ASSESSMENT REPORT

St George Hospital, Kogarah SSD 7024 MOD 2

Figure 2: North Elevation – Gray Street Car Park (source: Applicant's Modification Report)

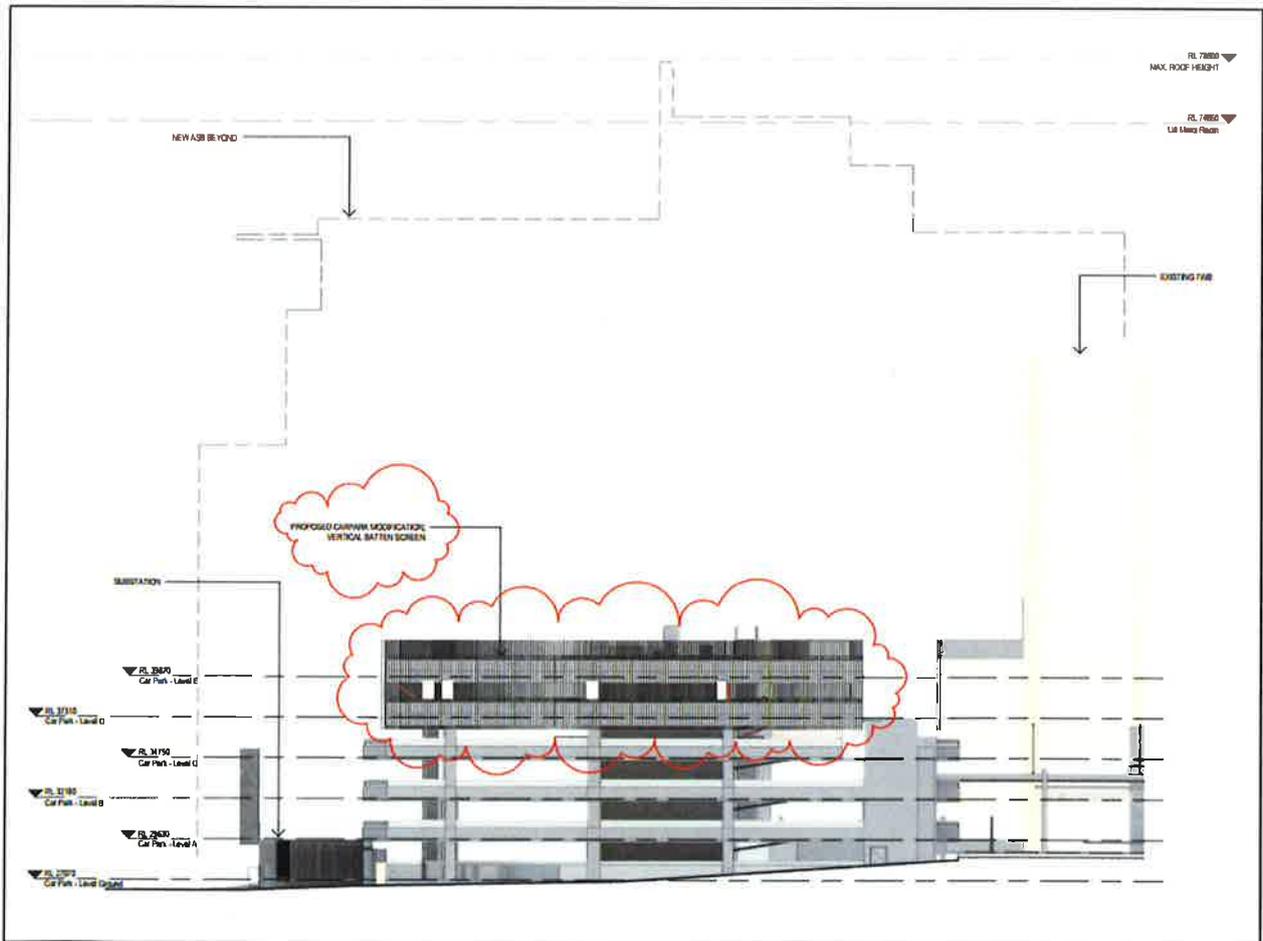
While the structure of the two additional levels has been completed, construction of the treatment to the edge of the levels has not commenced. In this regard, the proposed changes involve a redesign of the previously approved balustrade and barrier system. At Level E, the approved design of the one metre high masonry balustrade wall is proposed to be substituted with an Armco style crash barrier and 2.2 m high vertical powder coated aluminium batten screening in a dark grey finish (representing a net increase in height of 1.2 m over the approved balustrade). Below on Level D, the perimeter will also be fitted with an Armco style crash barrier and an extension of the Level E screen above. There is no change in the number of car spaces, nor any structural changes to the internal layout.

The proposed perimeter screening is represented in **Figures 2 to 4** below.

Figure 5: 9 am shadow diagrams June 21 (source: Applicant's Modification Report)

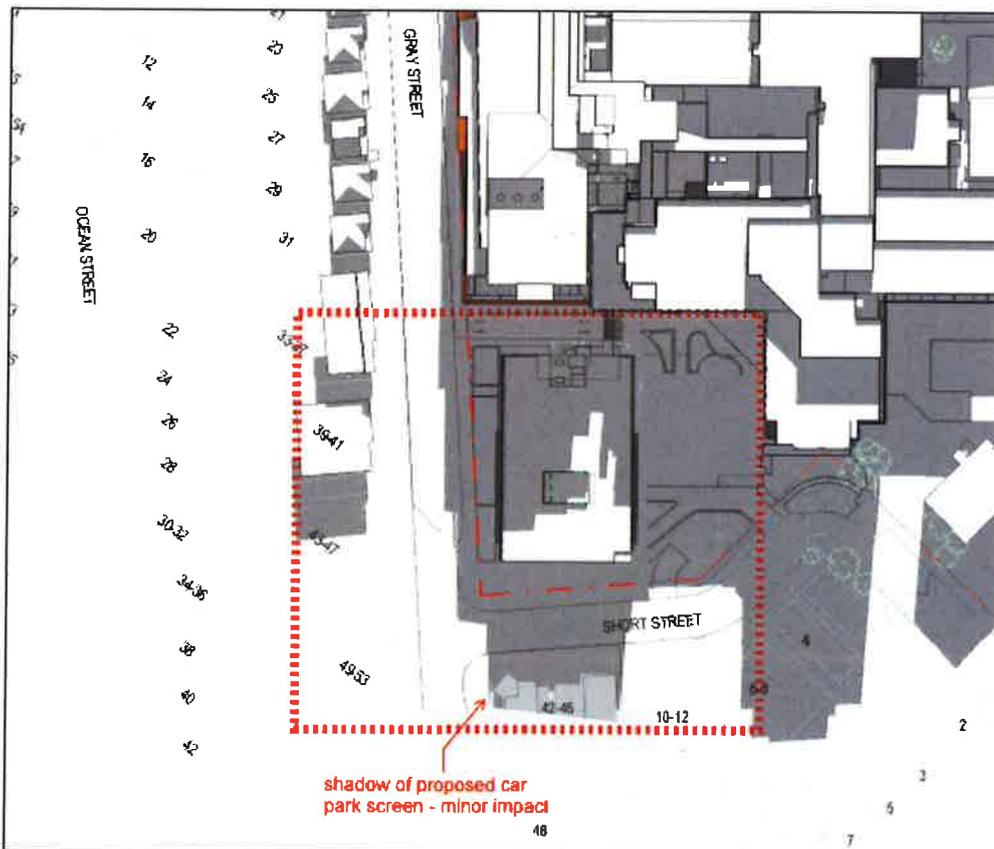
As part of the modification application, the Applicant provided a solar access study to outline the potential shadows created by the perimeter screening. The shadows cast by the increase in height of the 1.2 m perimeter screening increases the 9 am and 2 pm shadows cast in mid-winter (refer to **Figures 5** and **6**). The perimeter screening height increase does not affect the 3 pm shadows as the ASB behind the carpark already overshadows the area that the carpark would otherwise shadow.

Between 9 am and 3 pm on June 21, the new perimeter screening of the multi-level carpark results in the following shadowing impacts on residential flat buildings in Gray Street and health care facility in Short Street:

- overshadowing before 10 am predominantly falls on apartment roofs and does not impact on areas of private open space

- between 10 am and 12 pm, overshadowing falls on the public footpath and Gray Street and does not affect residential properties
- between 12 pm and 1 pm approximately 1.7 m to 1.9 m of additional shadow falls on the front portion of 42-46 Short Street (health care facility) where large established trees already shadow this part of the property
- at 2 pm the front of 42-46 Short Street is already overshadowed and any additional shadow is cast over the roof
- at 3 pm the ASB to the north overshadows the carpark and adjacent properties.

Therefore, the proposed modifications result in minimal overshadowing impacts to living areas or areas of private open space and are therefore considered acceptable. Neighbouring residential properties will continue to receive an appropriate amount of sunlight during the winter solstice.
